From: Chao, Ming-tai
To: ["Mike Rice"](#)
Cc: [Shackelford, Dennis](#); [Williams, Ray](#)
Subject: RE: Permit Application for Craven LCIDLF
Date: Friday, August 16, 2013 9:10:00 AM

Correspondences - e-mail
Date: Au 14 – Aug 16, 2013
Solid Waste Section
Raleigh Central Office

APPROXIMATE BOUNDARY
FOR THE
LESS THAN 2 ACRE LCID LANDFILL SITE
FOR
R.J. BUSHHOGGING, INC.

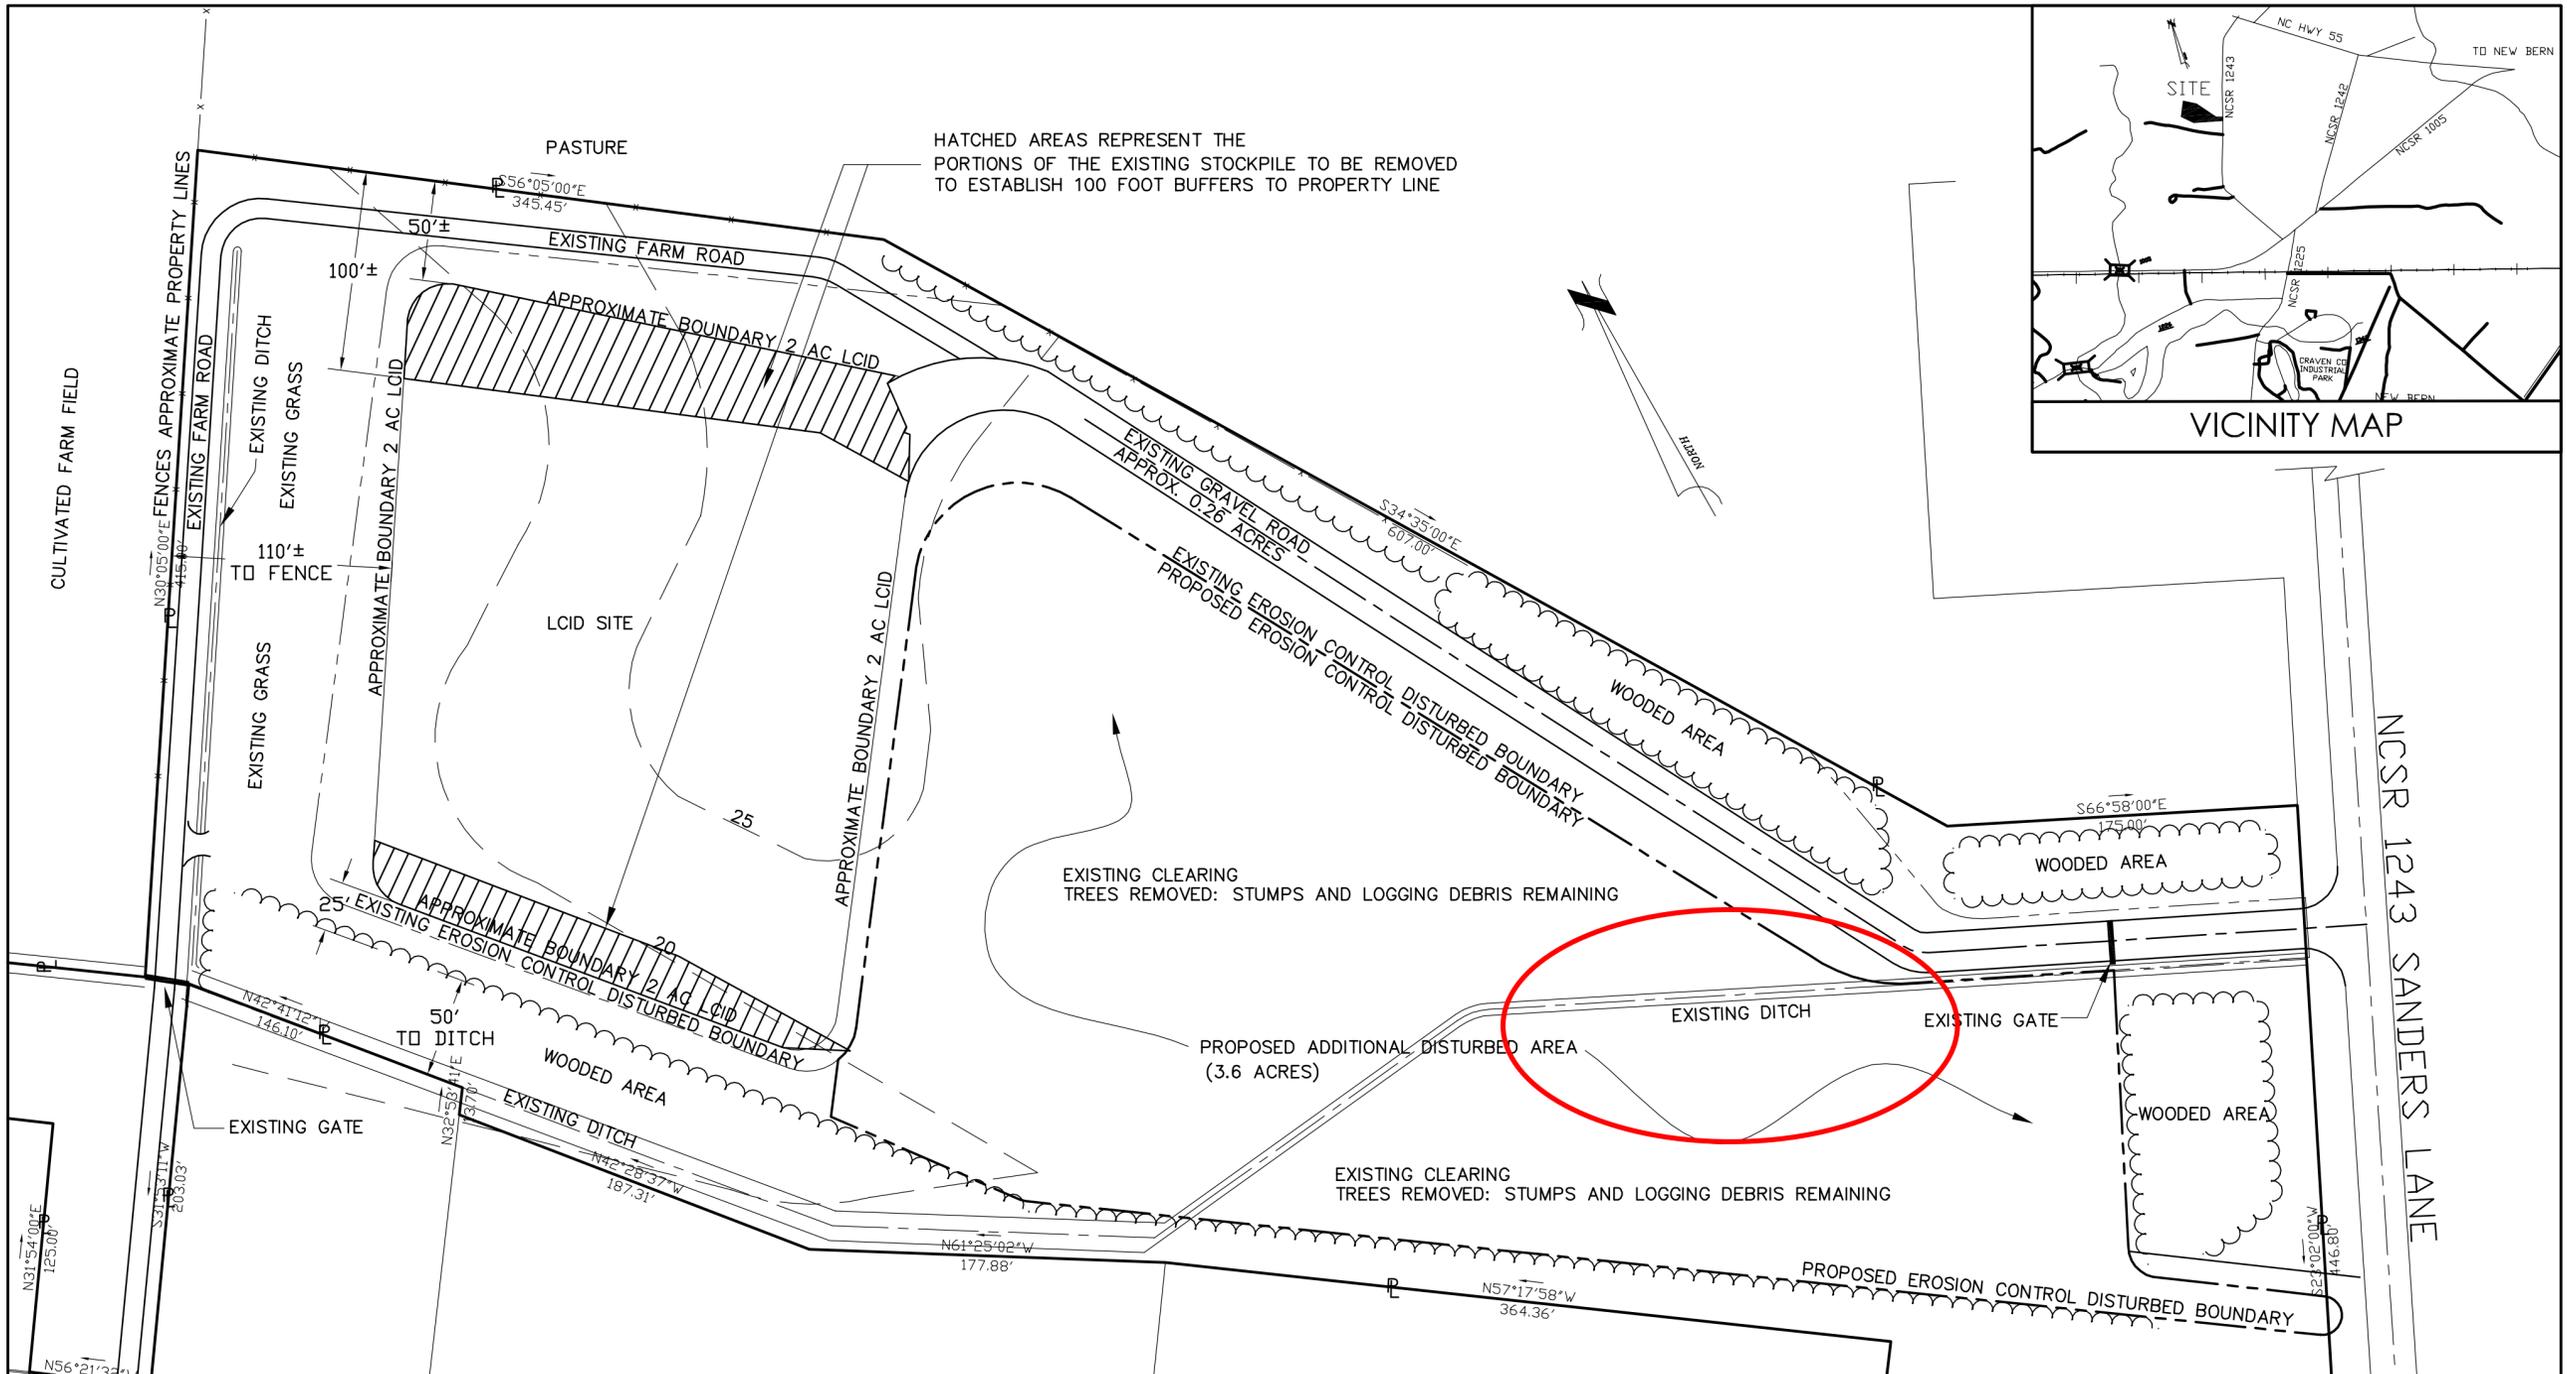
The buffer requirement. On the site wide drawing, an existing ditch is located at the site entrance area and less than 50-feet away from the proposed LCID waste footprints (I circled the area of concern on the attached drawing). This ditch was not shown on the previous submittal. I need you to confirm if this drainage ditch is an intermittent one or perennial one. If it is a ditch carrying flow year-round, you need to revise the waste foot prints for the new LCIDLF to meet the requirement stated in Rule .0546(9)(a). Have a wonderful day.

In answer to your question, the exiting ditch located at the site entrance is ephemeral, carrying only stormwater runoff during and immediately after rainfall. This is the case for all of the ditches within the property containing the LCID.

To provide additional information, I offer the following: That ditch was shown as a proposed ditch on the previous drawing between the labels "existing cable gate" and "existing paved entrance." The ditch was copied directly from a similar drawing that was prepared by us for Mr. Robert Jones, of R.J. Bushhogging, Inc. in 2005. The portion of ditch that is labeled "existing" in our revised drawings is actually a remaining portion of a ditch that existed prior to Mr. Jones' expansion of his notification site (see attached drawing). Information gathered while making the revisions prompted by your review comments revealed that our depiction of that ditch was drawn in the wrong location. The current drawing depicts the ditch closer to its actual location (based upon aerial photography). We removed the remainder of the proposed ditch to eliminate concerns about its proximity to the disposal area.
